No.EL/3.2.1/2

**MODIFICATION SHEET NO. RDSO/WAM4/160**

**Modification to improve the oil circulation in the neck portion of the locomotive transformer.**

DETAILS OF MODIFIED OIL CIRCULATION SYSTEM IN FREIGHT LOCO TRANSFORMER	
R.D.S.O. ELEC. DTE.	SKEL - 4018

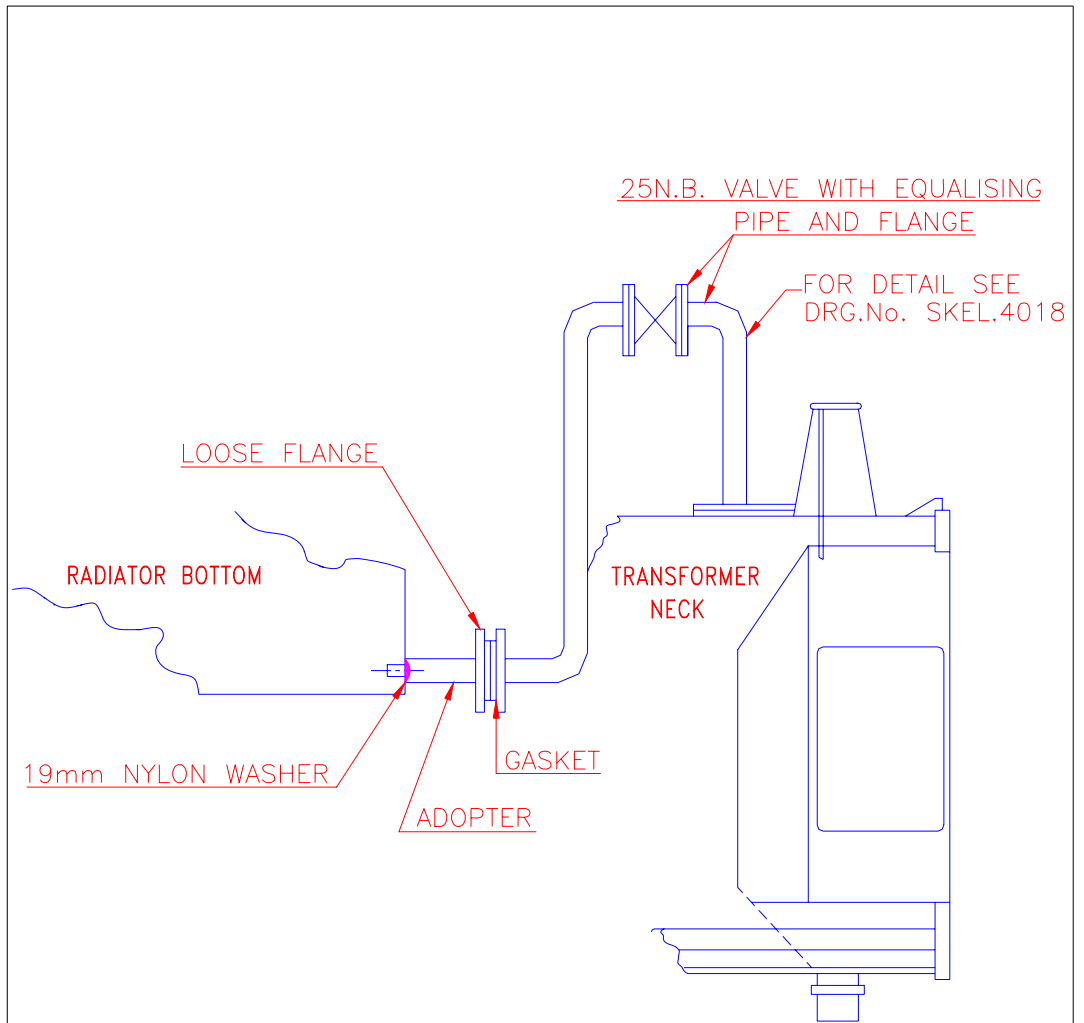
Railways have reported cases of insulation deterioration/failure of transformer auto winding leads. Investigations have revealed that the main reason for such failures is the presence of large amount of sludge in the neck portion with practically no movement of oil in the region. In order to overcome the problem it has been decided that the oil circulation in the transformer neck area should be increased by bleeding a small amount of oil from the bottom of the radiator and injecting the same in the neck of the transformer as shown in SK. EL.-4012.

Assemble an equalising pipe from the bottom of the radiator to the neck of the transformer as shown in schematic sketch SK. EL.-4010.
